Docket Number:	17-BSTD-02
Project Title:	2019 Title 24, Part 6, Building Energy Efficiency Standards Rulemaking
TN #:	222900
Document Title:	McHugh Energy Comments on Proposed 2019 Standards
Description:	Corrected version of a comment submitted to staff on 3/5/2018.
Filer:	Adrian Ownby
Organization:	McHugh Energy Comments
Submitter Role:	Commission Staff
Submission Date:	3/6/2018 9:35:24 AM
Docketed Date:	3/6/2018

Re: Docket No. 17-BSTD-02 – Flicker Reporting in Reference Appendix JA8

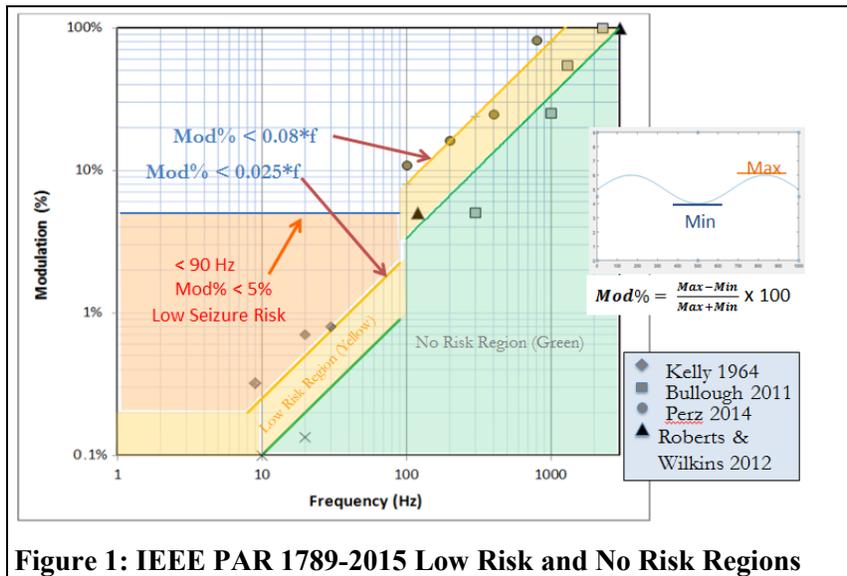
A key outcome of this synthesis of the research to date was a recommendation document that included a two dimensional risk map of frequencies and modulation (%) as shown **Figure 1**, with three primary regions: 1) No Risk Region (Green) where there is little expectation of any physiological effect, also known as the “No Observable Effect Level” (NOEL). This is where physiological response so far is not measurable. 2) Low Risk Region (Yellow) where a physiological response is detected but the response is

small and deemed to be unlikely to be damaging and 3) Not Low Risk Region (White) where there may be a range of risk from not much risk to the severe risk associated with triggering epileptic seizures or vertigo with relatively modest amplitude modulation at low frequencies. If it turns out that designing LED drivers to meet the IEEE standard is relatively inexpensive and does not have other deleterious effects on performance, this would seem to be the prudent thing to do.

Figure 2: JA10 broadband modulation data for showing compliance with IEEE PAR 1789 guidelines for low risk

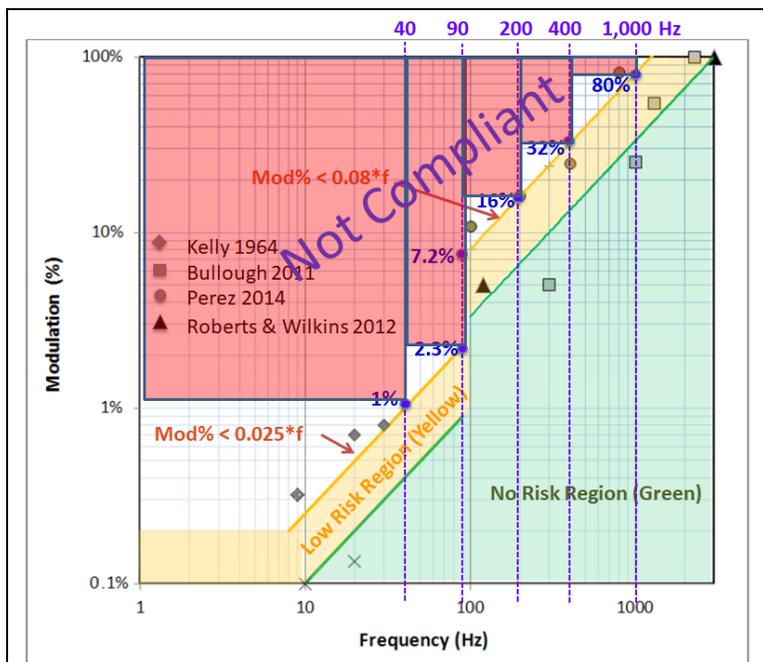
Products that comply with the maximum percent amplitude modulation in **Table 1** would reflect equipment performance below the red boxes shown in **Figure 2**. In other words products with amplitude modulation above the limits listed when plotted would be in one of the red boxes in the upper left-hand corner of Figure 2 that are labelled “Not Compliant.”

The 16% modulation limit for the low-pass filtered results with 200 Hz cut-off frequency is around 0.58 SVM for a 120 Hz sinusoidal waveform. This is significantly less than the 1.6 SVM proposed criteria in NEMA 77. The JA10 metric evaluates percent modulation of the waveform of the light output with all the frequency components above the cut-off frequency removed.

The first two columns of this table would reflect equipment performance below the red boxes shown in Figure 2. As discussed above, the third column represents some relief when dimmed to 20% by requiring the IEEE standard for most of the frequencies, but for the data where the virtual low pass filter has a 90 and 200 Hz cut-off frequency, the maximum amplitude values are equivalent to 1.4 times the IEEE PAR 1789 recommended values. These increased values are in the shaded cells in the third column. Note when dimmed to 20%, the 22% maximum amplitude modulation value for the 200 Hz cut-off frequency is comparable to a SVM = 0.78 for a 120 Hz sinusoidal waveform. This would address all the light sources except directional lamps. A similar approach could be used to evaluate what are
